Subject: FW: [Ext]20 Henry Graf Jr. Road, Newburyport, MA - Plan Revisions 05.15.2020
Attachments: 20 Henry Graf Jr. - Revised Plans 05.15.2020.pdf

Attached please find revised Sheets C-1, C-2 and C-3 dated May 15, 2020 in response to a May 8, 2020 letter from Jon-Eric White of the Town of Newburyport Department of Public Services and comments from Deputy Fire Chief Steve Bradbury.

**SITE DEVELOPMENT PLANS
PROPOSED MEDICAL BUILDING
20 HENRY GRAF JR. ROAD
NEWBURYPORT, MASSACHUSETTS**

DWG. NO.: **C-1**

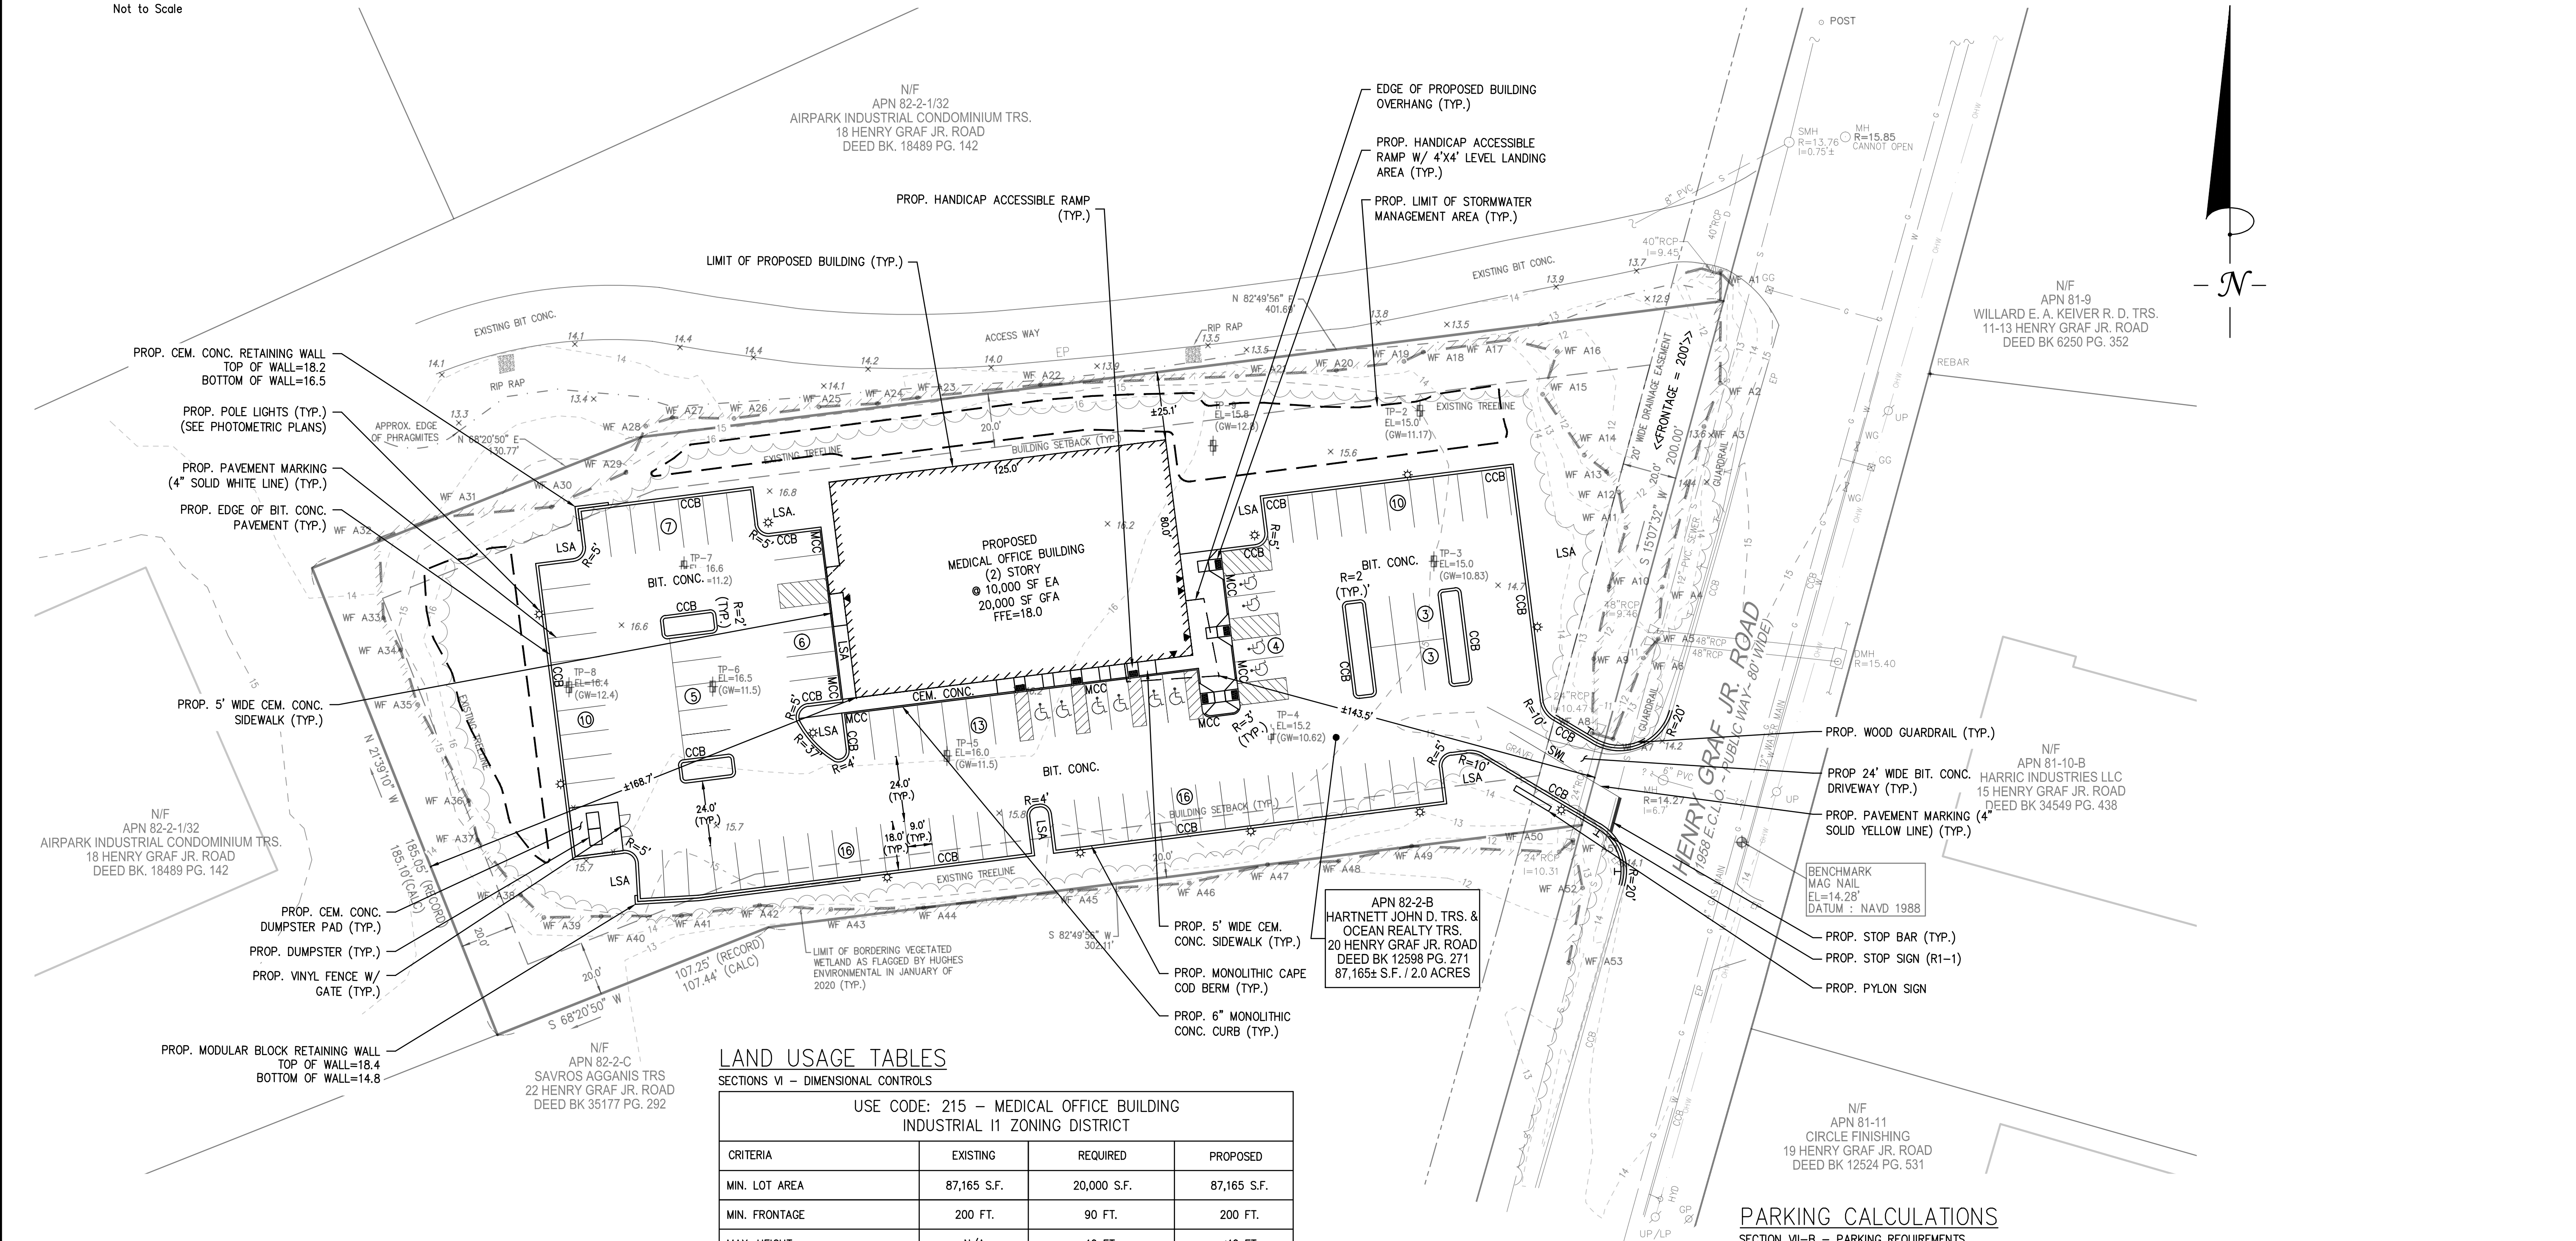
- The sidewalk on Henry Graf Jr. Road has been removed as requested;
- The grading at the entrance has been revised as requested to decrease the slope of the driveway. This grading on the north side of the proposed driveway entrance has also been revised with a slope of 3:1 and the existing 24" culvert extended by 10 feet as requested which results in the filling of approximately 150 square feet of the drainage ditch (flagged as BVW by Hughes Environmental);
- Guardrails have been added on both sides of the proposed entrance as requested;
- Handicap accessible ramps have been added along the sidewalk along the south face of the proposed building as requested;
- A fire hydrant was added on site that connects to the proposed 6" fire service as requested.
